SHEARON HARRIS NUCLEAR POWER PLANT
DOCKET NO. 50-400/LICENSE NO. NPF-63
REQUEST FOR LICENSE AMENDMENT

TECHNICAL SPECIFICATION PAGES

FIGURE B 3/4.4-2 (DELETED)

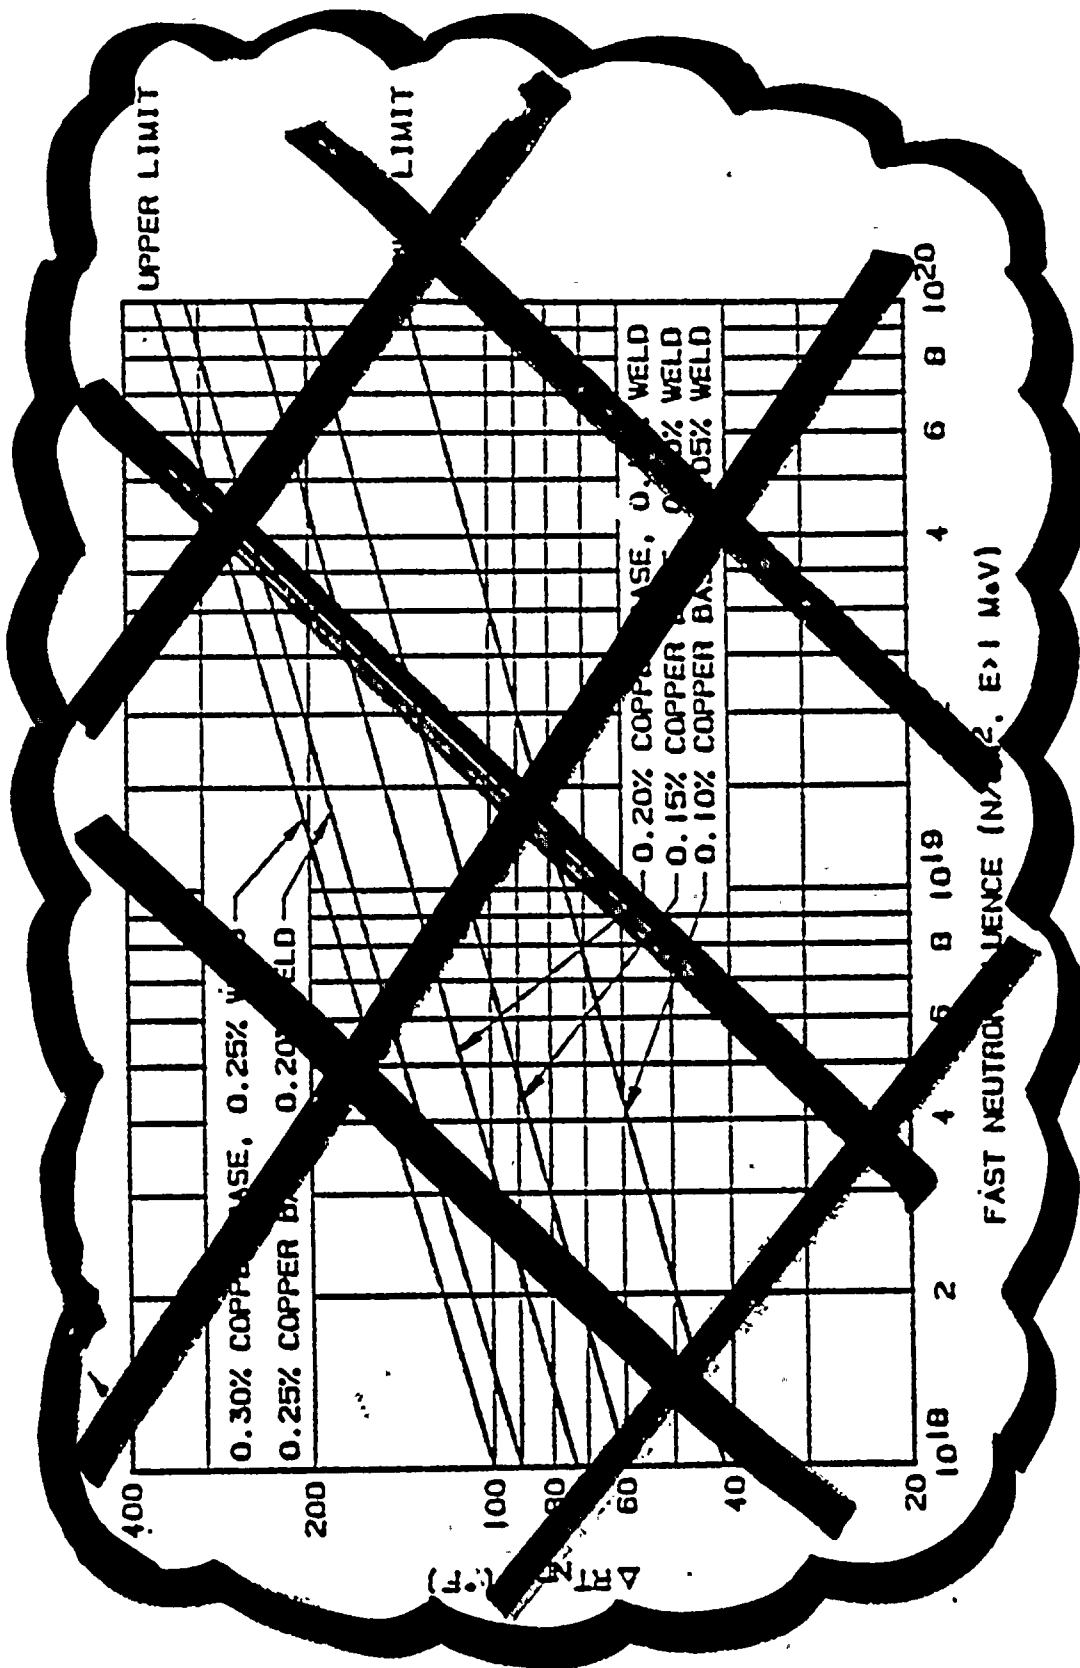
~~EFFECT OF TEMPERATURE AND COPPER ON CHANGE IN TEMPERATURE FOR REACTION VESSELS EXPOSED TO IRRADIATION AT 500°F~~
